SUBJECT: Forwards marked-up FSAR pages, indicating changes & justification for changes. Affect on SER noted.

September 23, 1986  
(NMP2L 0884)

Re: Nine Mile Point Unit 2  
Docket No. 50-410

SUMMARY OF FSAR CHANGES

FIGURE 6.2-70

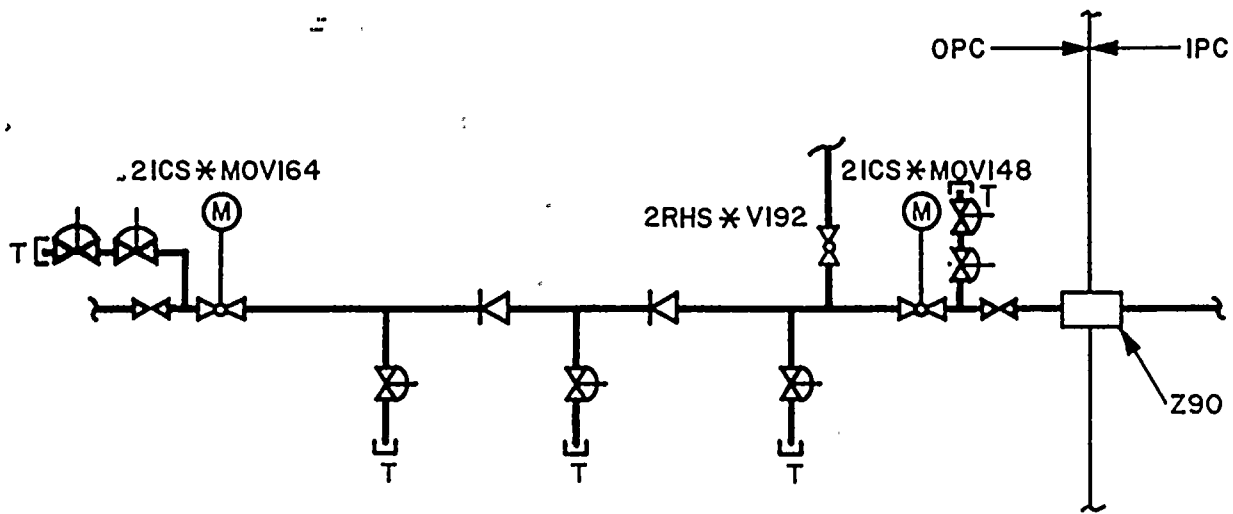
| <u>Page</u>   | <u>Change Description</u>  | <u>Justification</u>   | <u>Change Code</u> | <u>SER Impact</u> | <u>Tech. Spec. Impact</u> |
|---------------|--|--|--------------------|-------------------|---------------------------|
| Figure 6.2-70 | Change the title of the Figure from penetration "Z-9-" to "Z-90."        | This change is made to make the Figure title consistent with the information on the Figure.  | E                  | No                | No                        |

ISOLATION VALVE ARRANGEMENT  
FOR PENETRATION ~~Z-9~~ Z-90  
SHEET 36 OF 43

FIGURE 5-2  
SAFE LOAD PATHS  
FOR HEAVY LOADS REFUELING FLOOR  
NIAGARA MOHAWK POWER CORPORATION  
NINE MILE POINT-UNIT 2  
THE CONTROL OF HEAVY LOADS AT NMP2

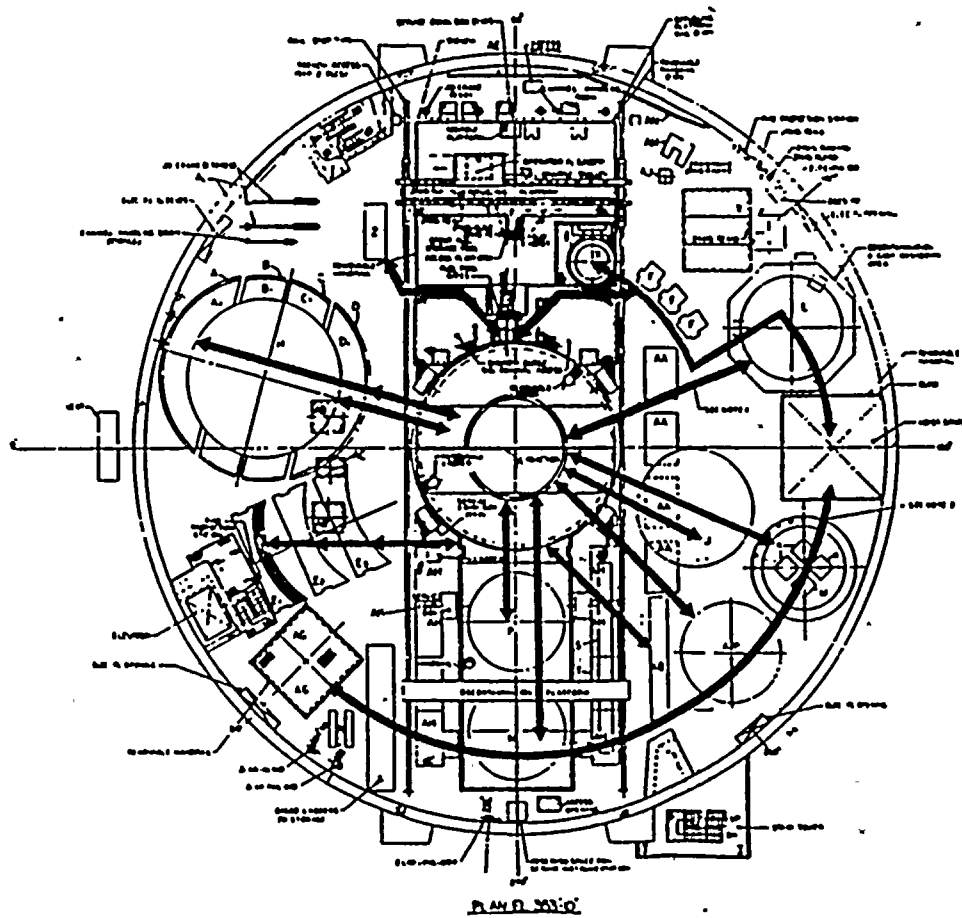
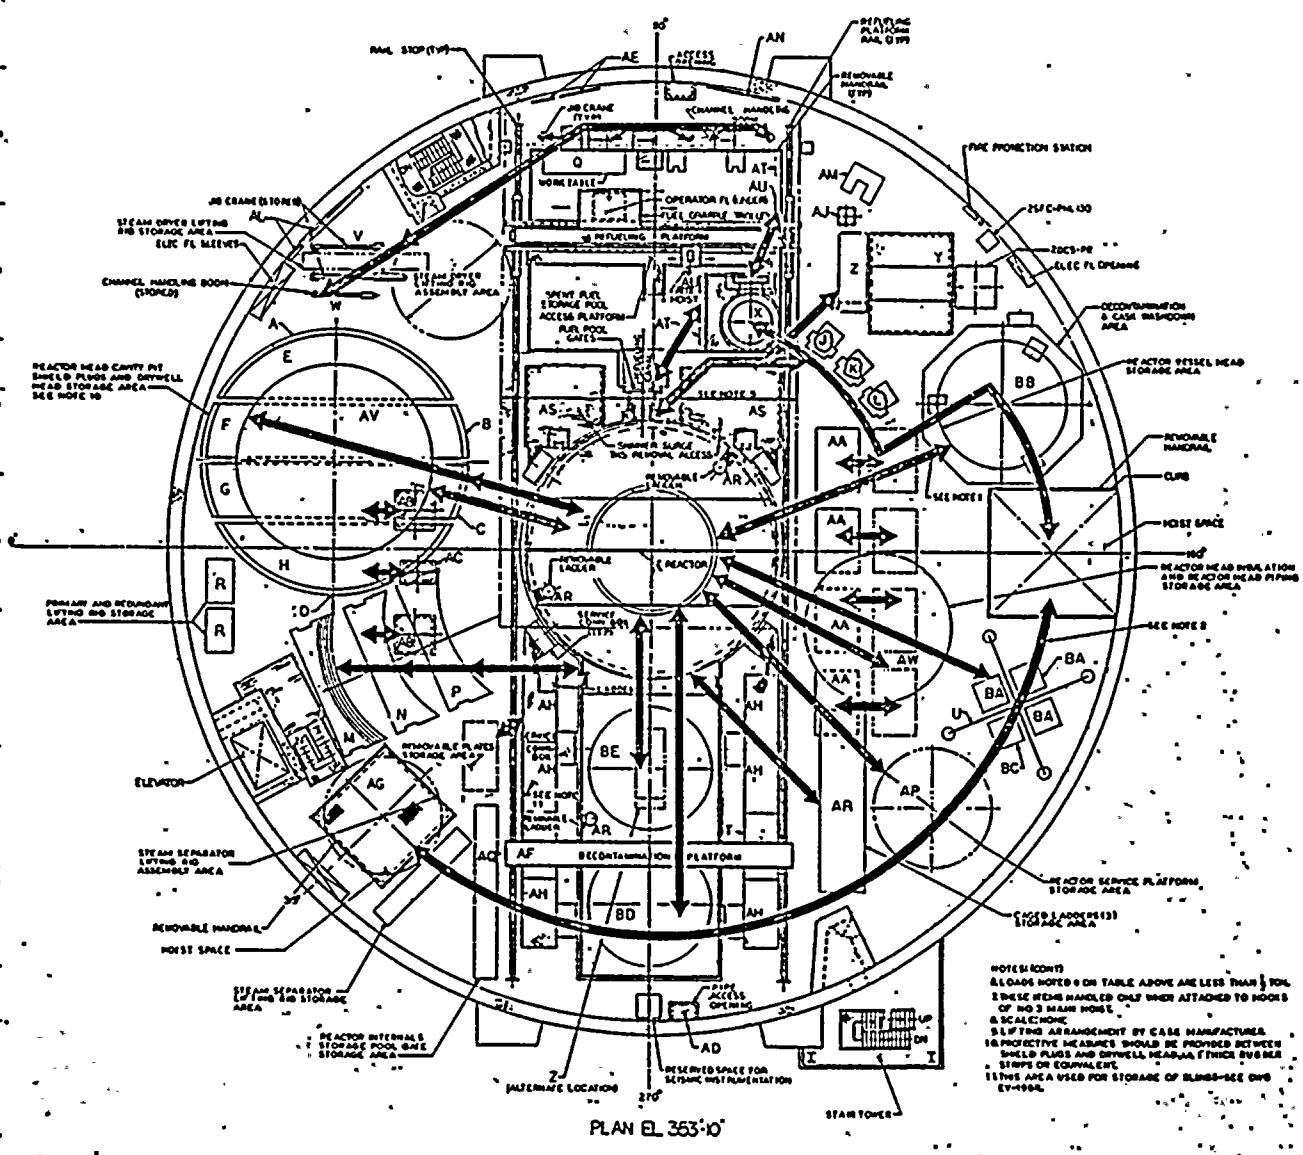
| <u>Page</u>  | <u>Change Description</u>   | <u>Justification</u>   | <u>Change Code</u> | <u>SER Impact</u> | <u>Tech. Spec. Impact</u> |
|--|---|--|--------------------|-------------------|---------------------------|
| FSAR Q/R<br>Heavy Loads<br>Table 3-3,<br>4-1 and<br>Figure 5-2 | The changes to Table 3-3 reflect final design lift weights and provides additional loads which are added to the table. The deletion to Table 4-1 reflects the shifting of loads.  | A load drop evaluation has not been performed for the loads previously listed in Table 4-1, Sheet 1 of 10 (25-ton auxiliary hoist). The subject loads may be handled by the No. 3 125-ton main hoist.  | SS                 | SER<br>Appendix G | No                        |

Replace with attached
